# Preliminary MRP-227- Rev. 1 RAI Response Strategies

**Kyle Amberge-PM**  
EPRI-MRP

July 12, 2017

MRP-227-Rev. 1 Figure 4-9

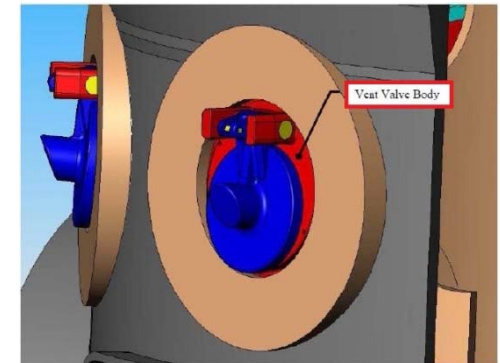
- **RAI Summary:** Why the addition of the vent valve bodies as Expansion link to the CRGT spacer castings (previously they were no additional measures)?
- **Preliminary Industry Approach:** Previously the original vent valve bodies were able to be screened out, but data for replacement vent valve bodies have not been fully gathered, hence they are conservatively screened in unless they can be shown to be below the screening criteria (see Table 4-4 Note 4)
- This may consist of CMTR reviews and/or a statistical argument, PWROG-15032-NP

MRP-227-Rev. 1 Figure 4-8(b)

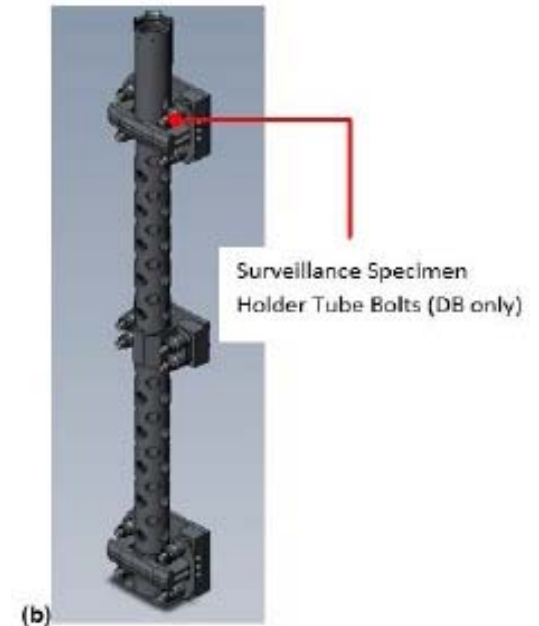
- **RAI Summary:** Why do the SSHT bolts have IC/ISR/Fatigue/Wear applicable in MRP-227-Rev. 1? Were the compression collars left out of the screening and FMECA process as an oversight and are they the same as the locking cups and tie plate in MRP-227-A?
- **Preliminary Industry Approach:** After determining more accurate fluence values for the SSHT bolts, the fluence was determined to exceed the screening criteria for IC/ISR. When IC/ISR is screened in, so are fatigue and wear. A plant-specific records search was performed in 2010 for DB and determined the details of the SSHT bolt and locking mechanism for DB, and the use of a compression collar was discovered at that time. This component was unknown during the development of MRP-227-A. The locking cups and tie plates are in addition to the compression collar. This component only exists at DB.

MRP-227-Rev. 1 Figure 4-2

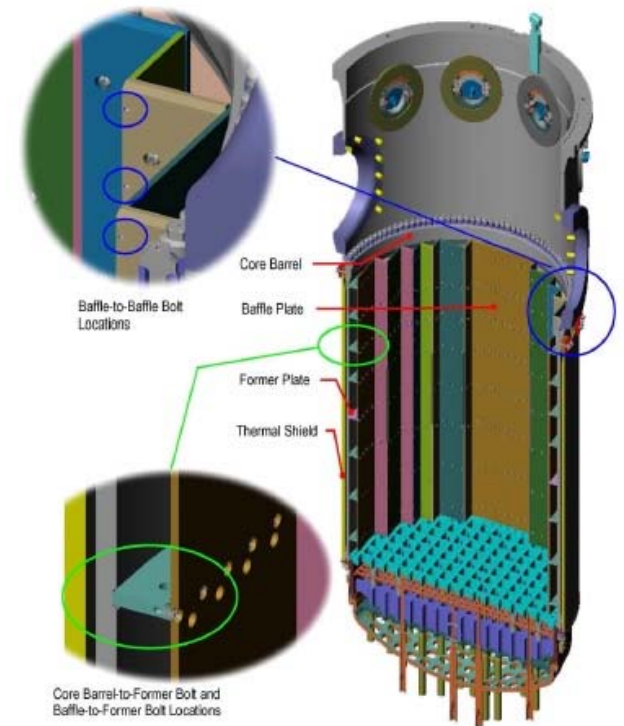
- **RAI Summary:** The primary link for the core barrel bolting locking devices/welds changed from “...locking devices, including locking welds, of baffle-to-former bolts or internal baffle-to-baffle bolts...” to “...locking devices, including locking welds, of baffle-to-former bolts and internal baffle-to-baffle bolts...” Does this mean you now need aging degradation in both types of locking devices/welds before Expansion?
- **Preliminary Industry Approach:** No, word change is editorial in nature only.

MRP-227-Rev. 1 Figure 4-3

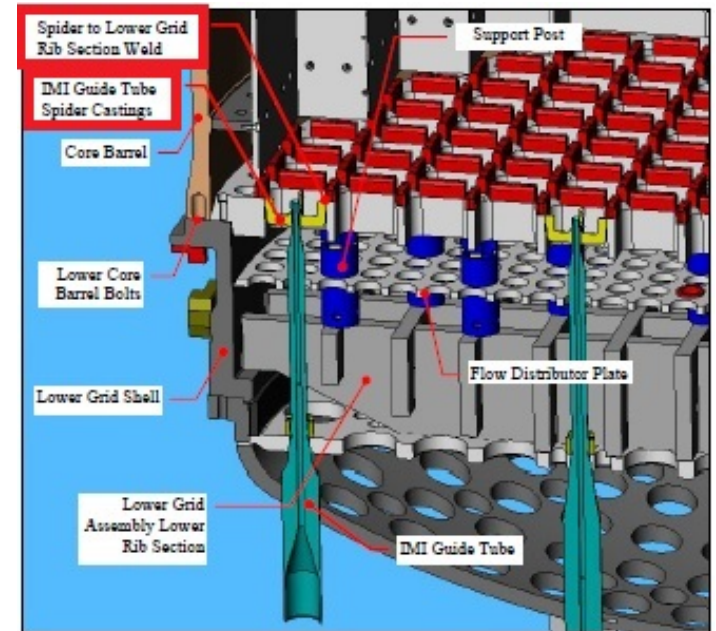
- **RAI Summary:** Explain why the examination coverage for the IMI guide tube spiders changed from “100% of top surfaces of 52 spider castings and welds to the adjacent lower grid rib section” to “Spiders: 100% of the accessible top surfaces and 100% of the accessible spider surfaces adjacent to the spider casting welds” and “Spider welds: 100% of the accessible welds to the adjacent lower grid rib section.”
- **Preliminary Industry Approach:** This is a clarification of the examination coverage by separating the spiders from the welds and does not change the actual inspection coverage.

MRP-227-Rev. 1 Figure 4-2

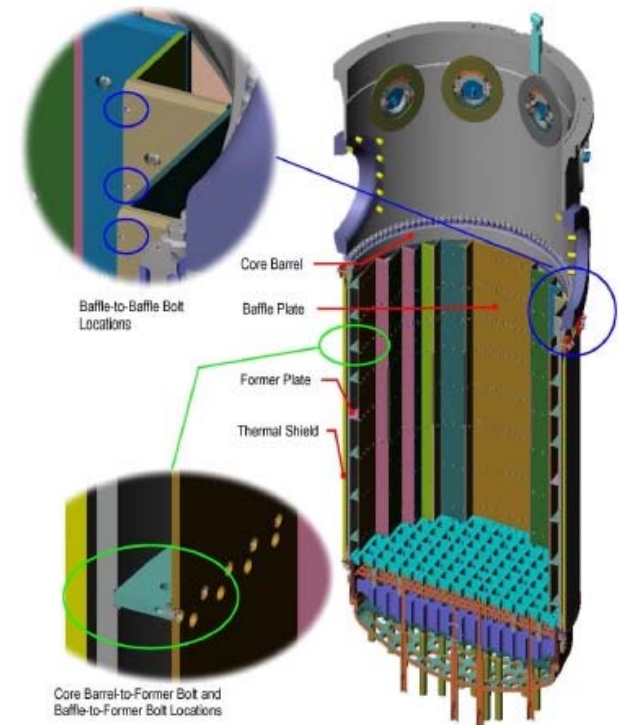
- **RAI Summary:** Does the initial baseline UT examination schedule for the baffle-to-former bolts in MRP-227-Rev. 1 assume an examination of baffle-to-former bolts has been completed within two RFOs from the beginning of the period of extended operation? If not, justify changing the schedule for the baseline UT examinations of the baffle-to-former bolts
- **Preliminary Industry Approach:**
- Yes, the initial baseline UT examination schedule for the B-F bolts in MRP-227, Rev. 1 assumes an examination of B-F bolts has been completed within two refueling outages from the beginning of the period of extended operation for each B&W unit.

MRP-227-Rev. 1 Figure 4-2

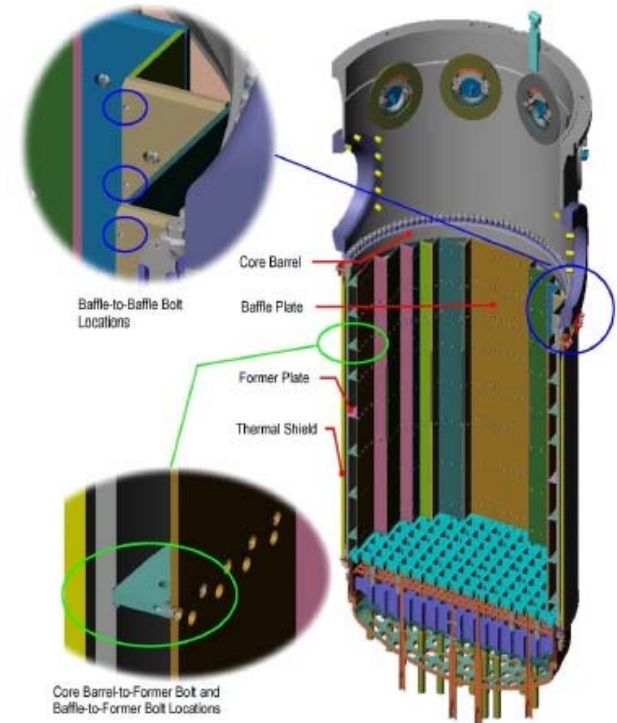
- **RAI Summary:** Explain why the language regarding rows 3, 4, and 5 and 25% of the bolts on a single plate was removed from the Expansion criteria of the baffle-to-former bolts.
- **Preliminary Industry Approach:**
- Parts a and b – The Expansion criteria were updated to include only considerations for Expansion, i.e., determining that an active aging degradation mechanism in the baffle-to-former bolts is underway. Aging degradation drives the Expansion inspections.
- Note that clustering of failures of baffle-to-former bolts is not expected in the Babcock & Wilcox-designed units, per Customer Service Bulletin 16-02 (July 2016), which is also supported by operating experience to date in the Babcock & Wilcox-designed units.

MRP-227-Rev. 1 Figure 4-2

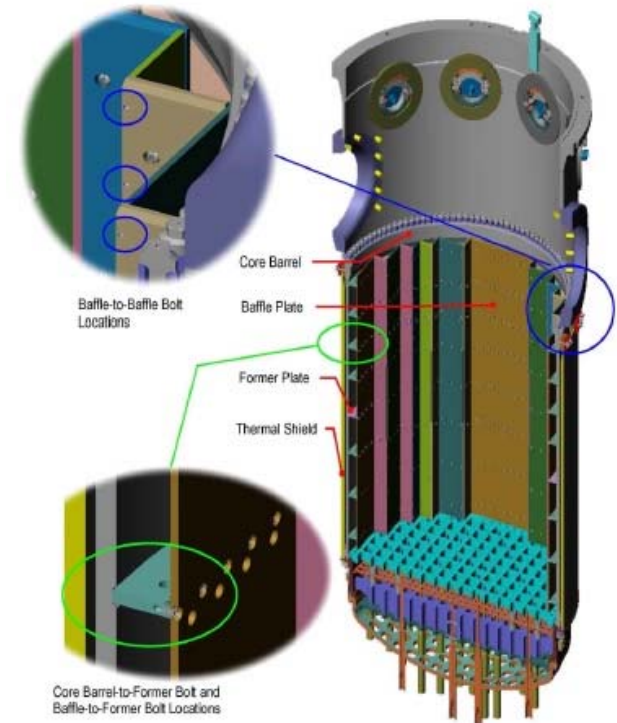
- **RAI Summary:** Provide technical justifications for the change in relevant condition and Expansion criteria text for the baffle plates. Clarify whether Expansion is only required if cracking links two or more openings or whether Expansion would be required if cracking is present within one inch of any opening.
- **Preliminary Industry Approach:**
- Part a – Due to the nature of irradiation embrittlement, this examination acceptance criteria is appropriate.
- Units have examined the baffle plates and thus far no relevant conditions have been identified
- Part b and c – The Expansion criteria entry currently listed in Table 5-1 of MRP-227-Rev. 1 for the baffle plates will be updated to be consistent with the relevant condition, as noted on the next page (updated text is bold-underlined).

Primary Item	Applicability	Primary Item Examination Acceptance Criteria	Expansion Link(s)	Expansion Criteria	Expansion Item Examination Acceptance Criteria
<p><b>Core Barrel Assembly</b></p> <p><b>Baffle Plates</b></p>	All plants	<p>Visual (VT-3) examination</p> <p>The specific relevant condition is readily detectable cracking connecting openings in the baffle plates (i.e., each bolt hole and flow hole).</p>	<p>Former plates</p> <p>Core barrel cylinder (including vertical and circumferential seam welds)</p> <p>Lower grid rib section</p>	<p><b><u>Readily detectable cracking (if confirmed) connecting openings in the baffle plates (i.e., each bolt hole and flow hole) shall require:</u></b></p> <p>a) An evaluation of the former plates and the core barrel cylinder for the purpose of determining continued operation or repair/replacement by the completion of the next refueling outage. Alternatively, repair/replacement activities may be initiated based on results of a best effort former plate and core barrel cylinder examination.</p> <p>b) That the VT-3 examination be expanded by the completion of the next refueling outage to include 100% of the lower grid rib section heat-affected zones adjacent to the IMI guide tube spider-to-lower grid rib section welds.</p>	N/A
